STATE OF MAINE
DEPARTMENT OF TRANSPORTATION
16 STATE HOUSE STATION
AUGUSTA, MAINE 04333-0016

January 19, 2023
Subject: Acadia Gateway
State WIN: 017163.03
Location: **Trenton**
Amendment No. 5

\\na.aecomnet.com\ifs\AMER\Boston\USB0501\DCS\Projects\TRN\60653001_MaineDOT_Acadia_Gateway\900_CAD_GIS\910_CAD_Sheet\A721.dwg Jan 13, 2023 - 4:24pm

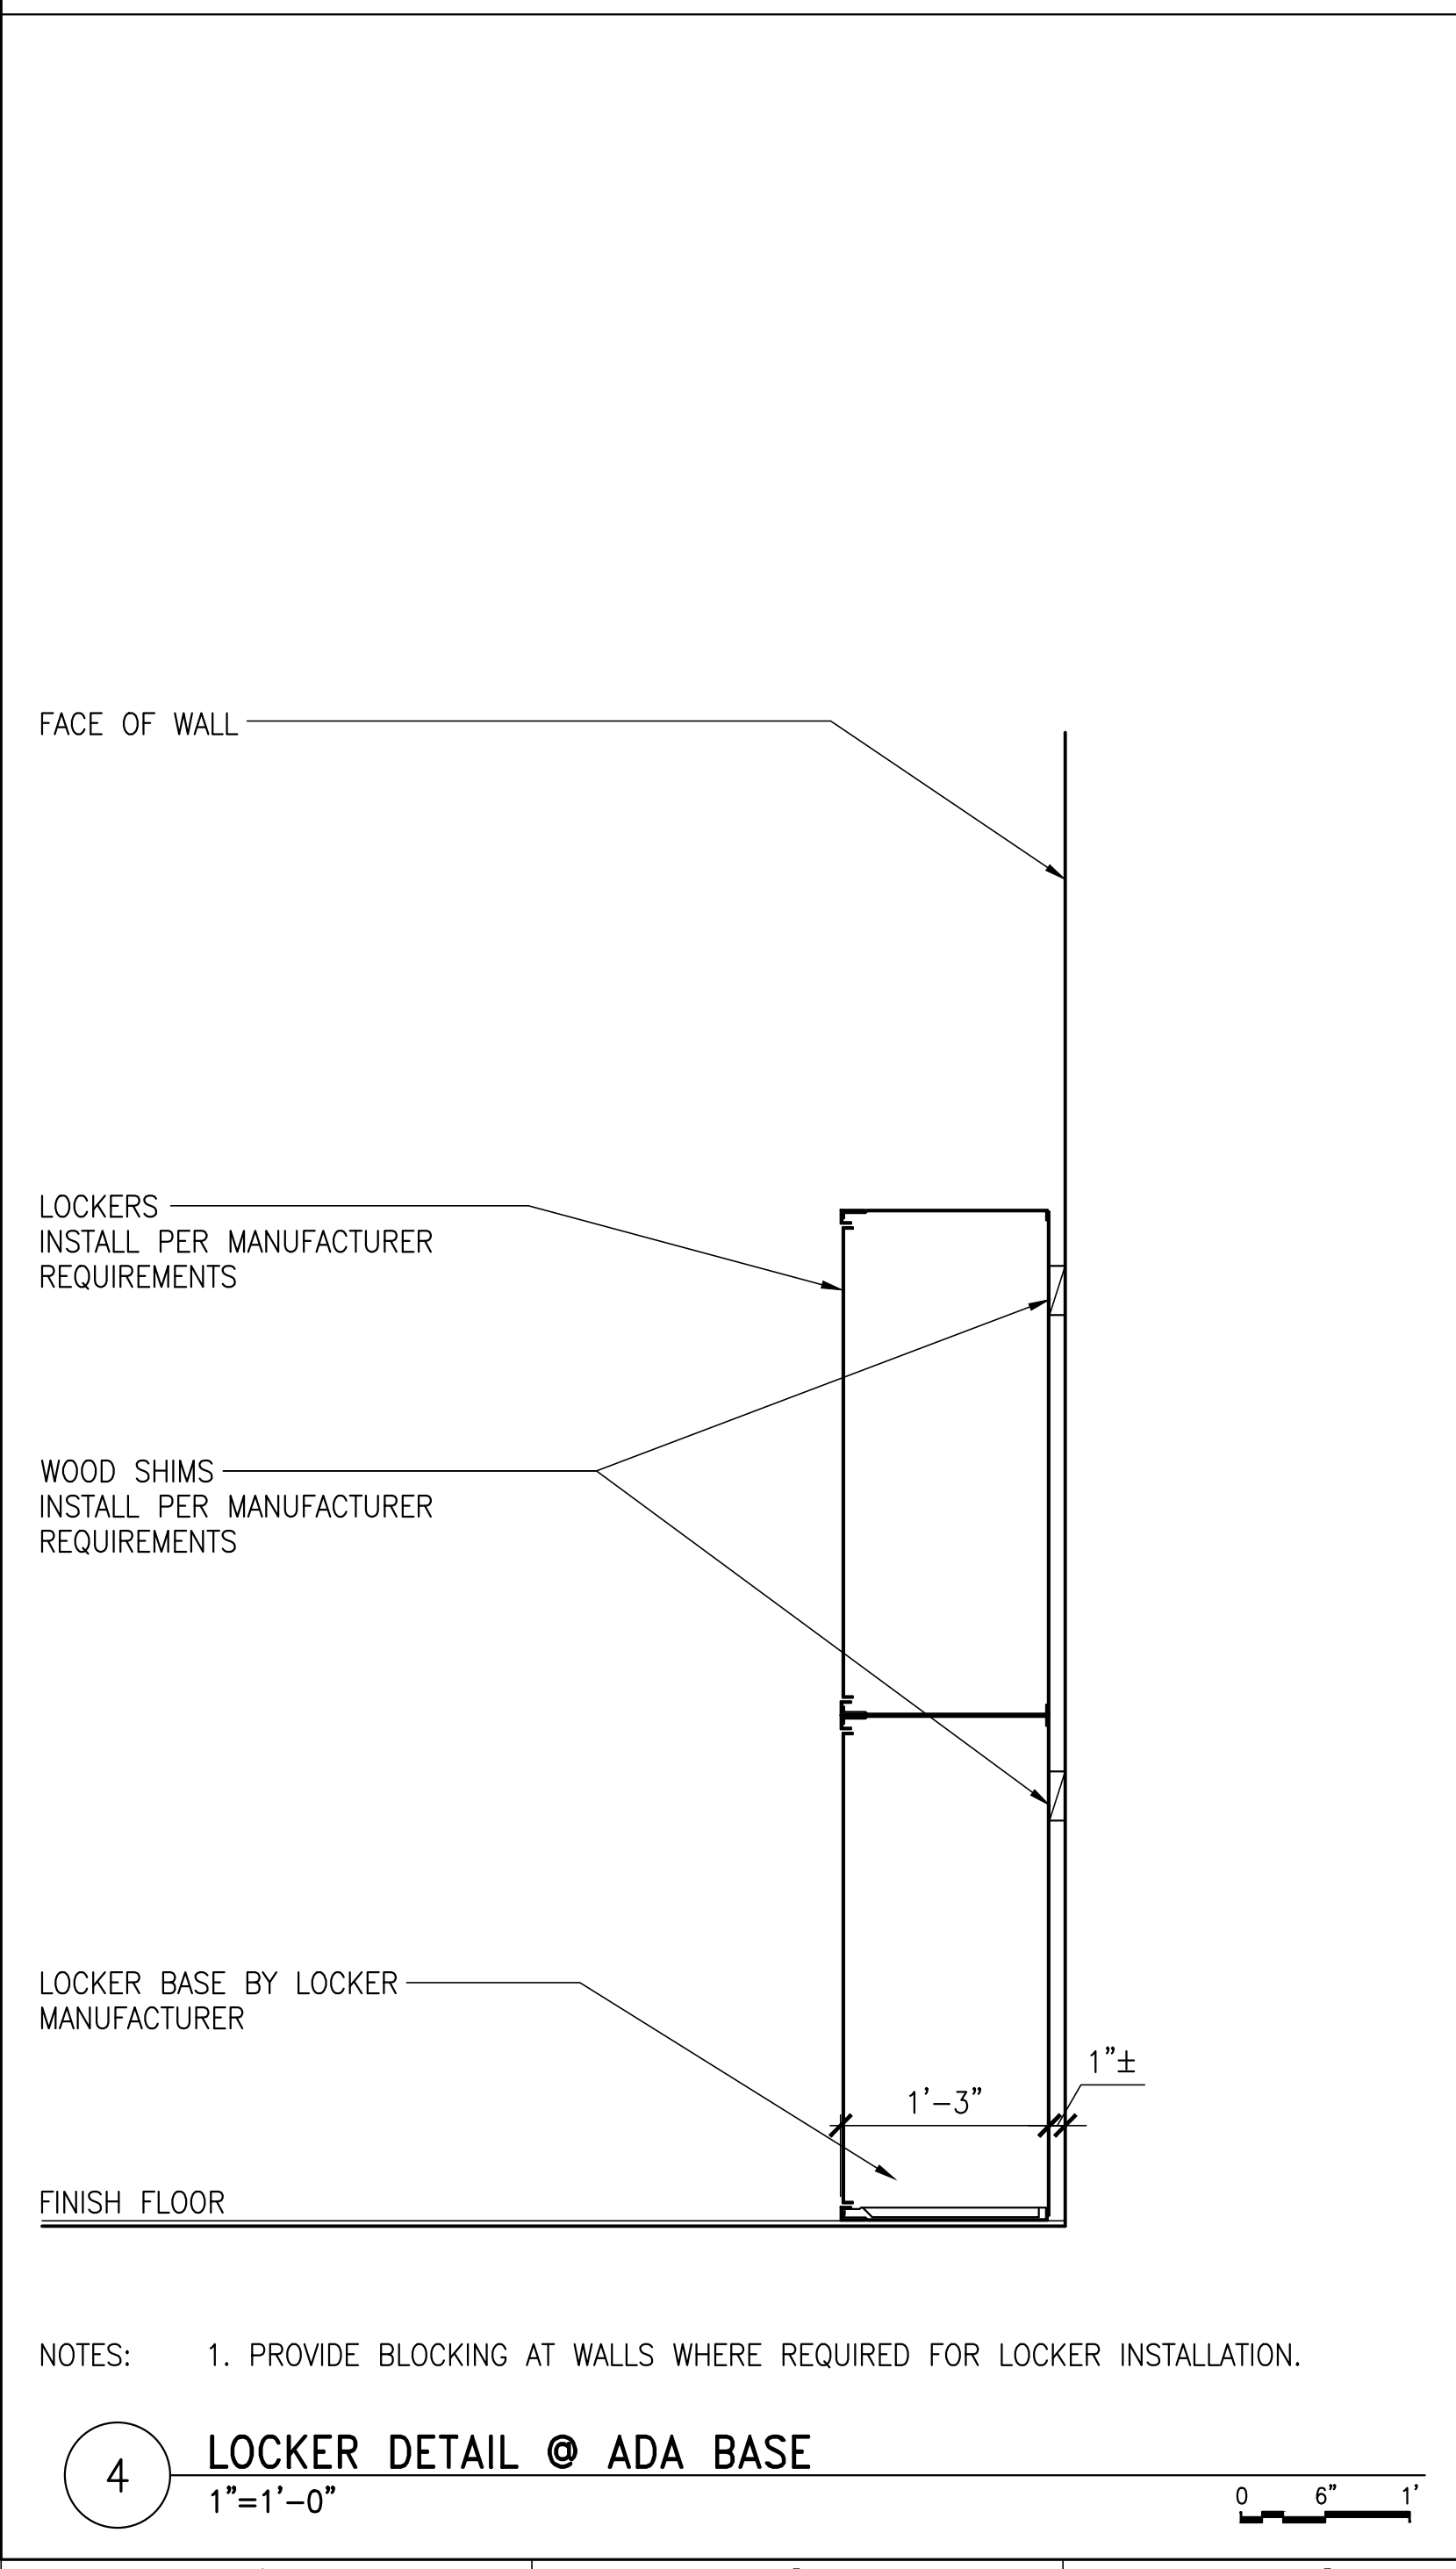
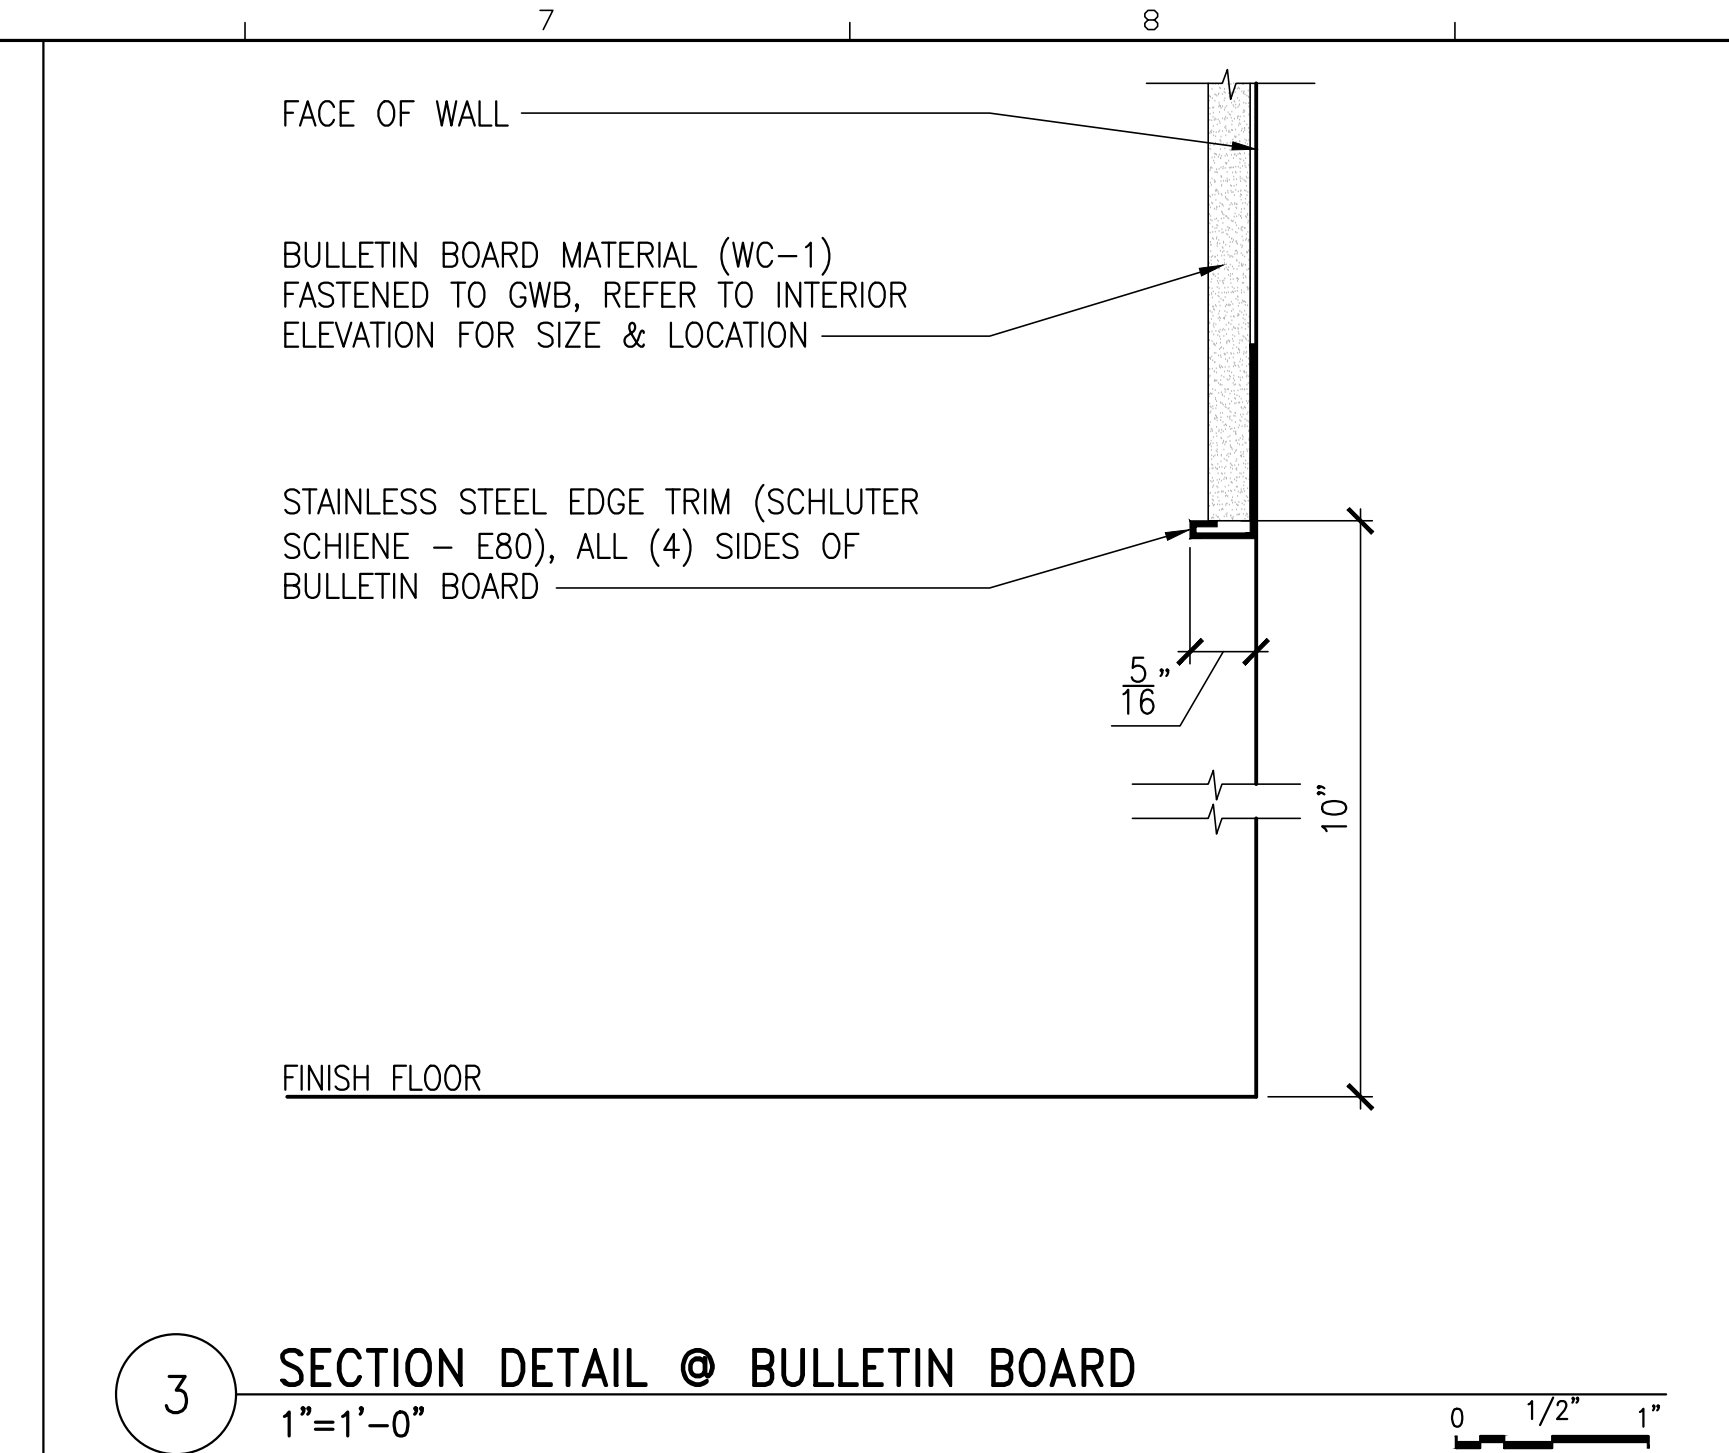
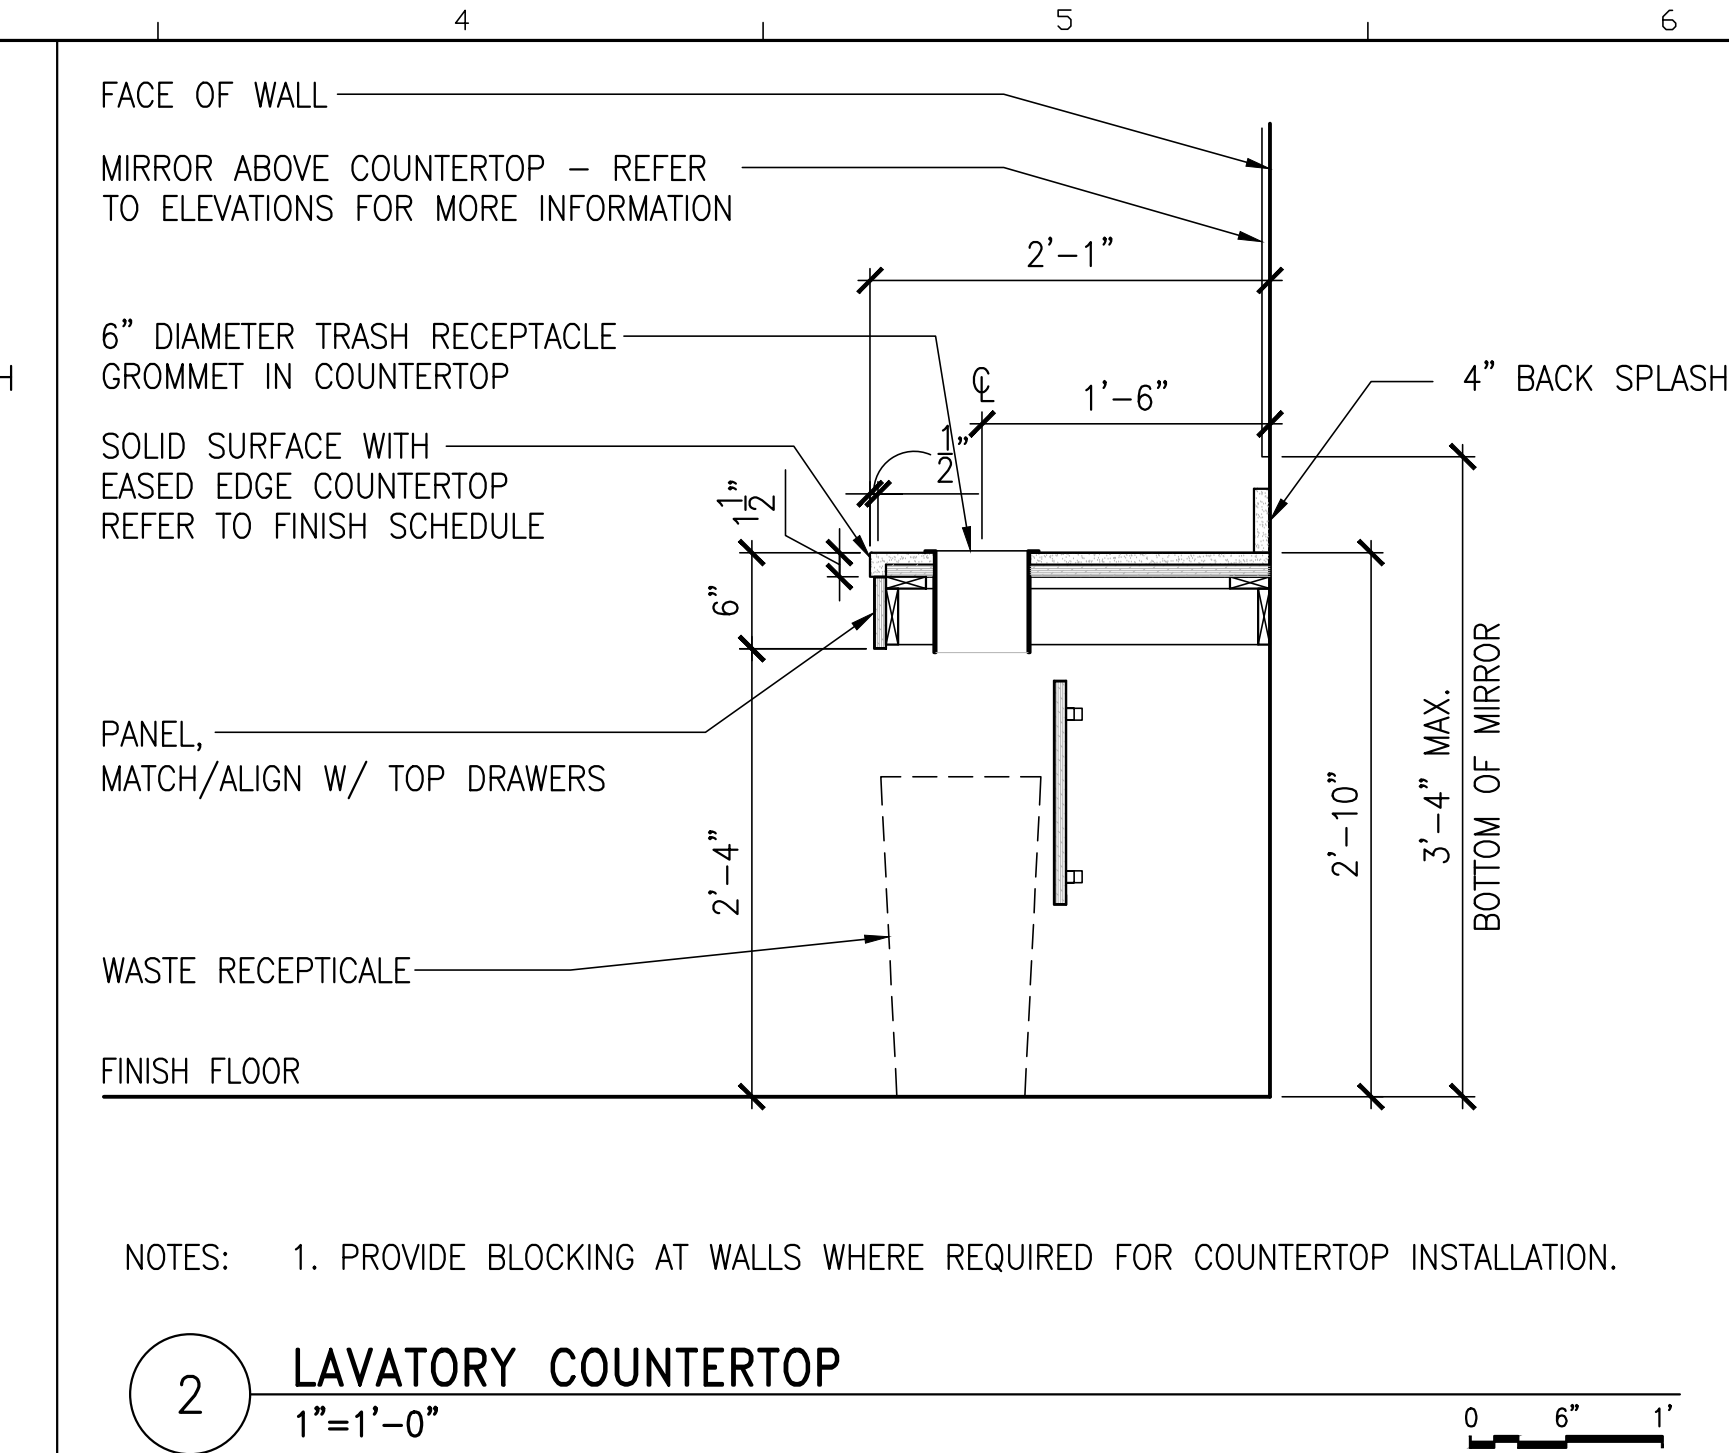
Question: There is a note about 2 counters/gates/panels at MW-03, Rm.#113 listed as TBD. Are details coming?

Response: Details for the two swing gates have been added to the drawings in Amendment #5. Sheets A202, A702, A703, A715, A721, A725 have been updated.

Amendment #5 Updates
-Added details 5,6,7

7 INFO DESK BACK ELEVATION
1"=1'-0" 0 6" 1"

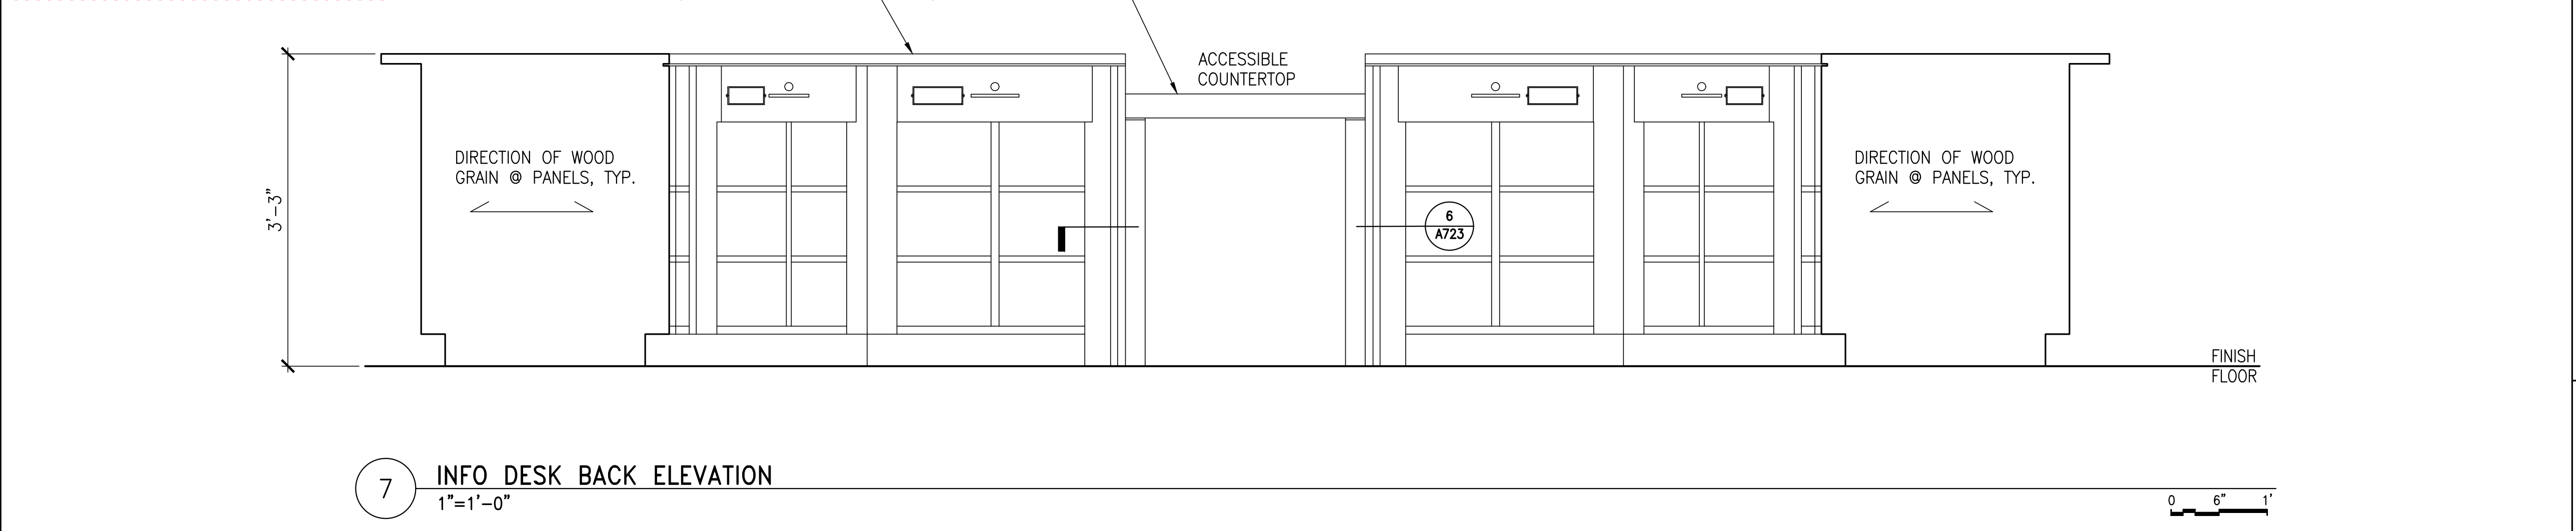
Question: There are notes about a lock system on the millwork cabinets but nothing in the specs. Is this lock system part of the door hardware package, master keyed for the building? Please list a type of lock for this.

Response: Basis of design for the lock type shall be Richelieu #LOC817910326D, 1 3/8" cylinder length, in brushed chrome. Keying will be determined during Construction.

NOTE:
ALL DRAWERS TO HAVE LOCKS FOR SECURITY, TYPICAL AT INFO DESK. BASIS OF DESIGN FOR LOCKS IS RICHELIEU #LOC817910326D, 1 3/8" CYLINDER LENGTH, BRUSHED CHROME.
